3. Levan-Sterling Subdivision

KPB File 2022-125

KPB File No.	2022-125
Plat Committee Meeting:	September 12, 2022
Applicant / Owner:	Mel Levan of Kodiak AK
Surveyor:	Jason Young, Mark Aimonetti / Edge Survey and Design, LLC
General Location:	Misty Morning Avenue, Sterling area

STAFF REPORT

PRELIMINARY PLAT

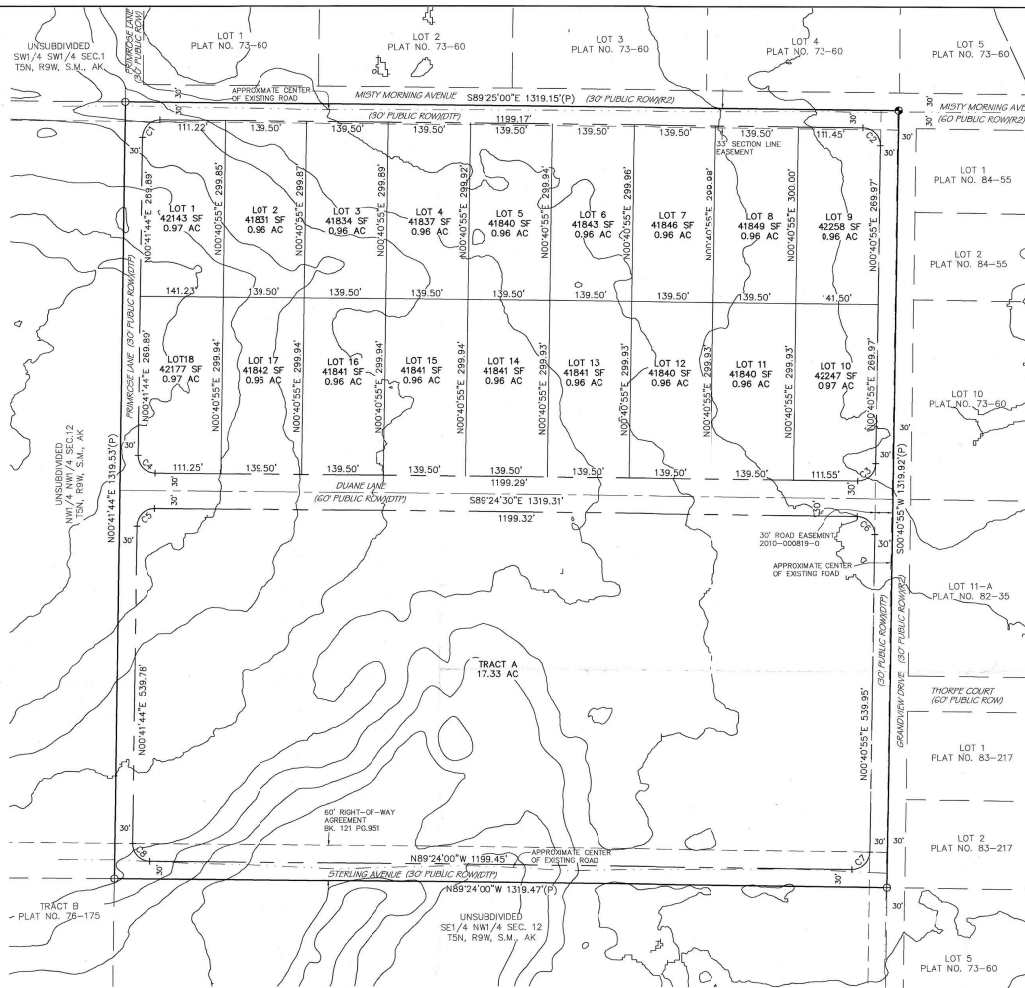
The preliminary plat shows a dedication along the north of a 30 foot right-of-way for Misty Morning Avenue that will be atop a 33-foot section line easement. The plat indicates that the abutting dedication and the dedication to the east is 30 feet on each side, per Grandview Subdivision, Plat KN 73-60 the dedications are 33 feet in width. **Staff recommends the depiction and labels be adjusted.**

Along the eastern boundary the plat shows a 30-foot right-of-way dedication for Grandview Drive to bring the right-of-way into compliance for width. Grandview Drive is constructed and maintained by the borough. This dedication is occurring atop a public easement granted by recorded document. **Staff recommends the easement label include "public" or a plat note be added that includes the details and description of location and states it is now within the dedicated portion of Grandview Drive.**

On the south of the plat a 30 foot wide dedication is proposed for Sterling Avenue. A new name will be required to be approved by the Addressing Officer as well as confirming all other names proposed on the plat. The plat shows along the proposed dedication the approximate center of an existing travelway. There is also a 60 foot wide right-of-way created by recorded document. Upon reviewing the document it needs to be clarified if that easement is public or private. ENSTAR reviewed the plat and noted there is a transmission line within the 60 foot right-of-way agreement and any development within the dedication should be coordinated with Alaska Pipeline Company (APC). The question remains if the depicted existing road is truly a road or the cleared area used by APC or the location of the pipeline. Upon staff's review of the proposed dedication, the existence of the 60 foot wide easement, and ENSTAR's comments, **staff recommends the transmission line be located, the surveyor work with APC and based on the line's location determine the best dedications along the southern boundary. Update the label to indicate if the right-of-way agreement is public or private or add a plat note with the details, and do one of the following or provide alternative that is agreeable by all parties.**

Site Investigation: The preliminary plat does not contain any steep areas or low wet lands. The land appears to be vacant with no neighboring encroachment issues. As discussed under the legal access portion of the staff report, the rights-of-way along the north and west are constructed and maintained by the borough. **Staff recommends the terrain be removed from the final plat.**

New utility easement as identified in note 2 as “the front 10’ of the 20’ Building Setback and the entire 20’ Building Setback within 5’ of side lot lines”. A typical building setback detail is provided that shows the setback and utility easements as described within the plat note. **Staff recommends the plat note include “granted by this plat”.**

*In references, check the spelling of subdivisions.
The existing road depictions may be removed.*

Staff recommendation: The legal description needs corrected to NE1/4 NW1/4

- C. The location, width, and name of existing or platted streets and public ways, railroad rights-of-way, and other important features such as section lines or political subdivisions or municipal corporation boundaries abutting the subdivision;
Staff recommendation: *North half of Misty Morning Avenue is 33' change on drawing*

- D. A vicinity map, drawn to scale showing location of proposed subdivision, north arrow if different from plat orientation, township and range, section lines, roads, political boundaries, and prominent natural and manmade features, such as shorelines or streams;
Staff recommendation: *The Misty Morning Avenue label appears along the right-of-way known as Robinson Loop Road. Add "Loop Road" to Scout Lake Loop Road Label. The Funny River label in section 24 should have "Road" added. If this is to reference the river the line depiction should be added to make it clear.*

- F. The location, width and name of existing and platted streets and public ways, railroad rights-of-way, easements, and travel ways existing and proposed, within the subdivision;
Staff recommendation: *Sterling is not an allowable street name. Continue Entrada Drive or receive an approved name from the addressing officer. Duane Lane should be Avenue and approval will be required from the Addressing Officer.*

- G. The status of adjacent lands within 100 feet of the proposed subdivision boundary or the land status across from any dedicated rights-of-way that adjoin the propose subdivision boundary, including names of subdivisions, lot lines, block numbers, lot numbers, rights-of-way; or an indication that the adjacent land is not subdivided;
Staff recommendation: *Lot to southeast needs to be corrected from Lot 5 to Lot 13.*

Staff recommendation: *Update the dedication of Sterling Avenue as determined by field survey.*

- Update plat note 5 to include KPB Code reference. "Roads must meet the design and construction standards established by the borough in order to be considered for certification and inclusion in the road maintenance program (KPB 14.06)."
- Remove "nominal five acres" from the wastewater note.

Staff recommendation: *Per the Certificate to Plat the ownership is under Mr. Levan's name only. Correct the ownership statement to be in the singular and remove Alice Levan from the statement. Comply with 20.60.190.*

- The dedication of a full 60 foot dedication that encompasses the travelway as long as the pipeline is within the adjacent utility easement or within edge of dedication, or

- providing a 30 foot dedication as currently proposed and make sure the pipeline is within the edge of the right-of-way or north of the dedication, or
- provide a reduced width for the right-of-way to not have the dedication atop the pipeline, or
- provide a full 60 foot dedication that is north of the existing pipeline.
